**REPLAT of SUB-LOTS 1,2,3 AND 4 in BLOCK K, in the RAVENNA BLDG.  
COMPANY ALLOTMENT No. 2 ROOTSTOWN TOWNSHIP**

**Case No.** 17-03  
**Reviewed By:** Haley Wachholz  
**Date Submitted:** 2-03-17  
**Due:** 3-08-17

**REPLAT of SUB-LOTS 10 & 11,  
BUTTERNUT RIDGE SUBDIVISION, BRIMFIELD TWP.**

**REPLAT of BLOCK B-R4,  
WINTERGREEN POINT SUBDIVISION**

Exhibit 2  
Replat

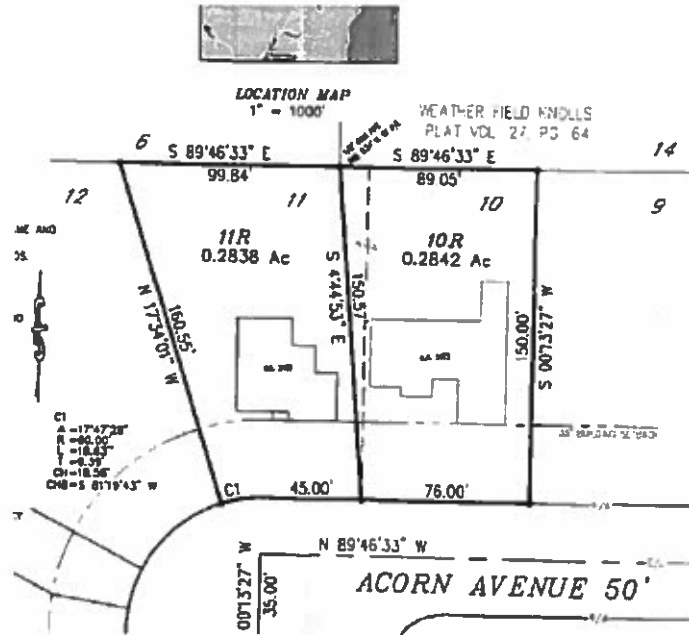
316.15 Building setback line- must be greater than 5' Proposed is 7'

**ANALYSIS:** There are two existing structures on lots 10 and 11, the proposed replat will move the lot line to a distance of 7 ft. from the structure on lot 10 R. The setback line must be at least 5 ft. so this is acceptable.
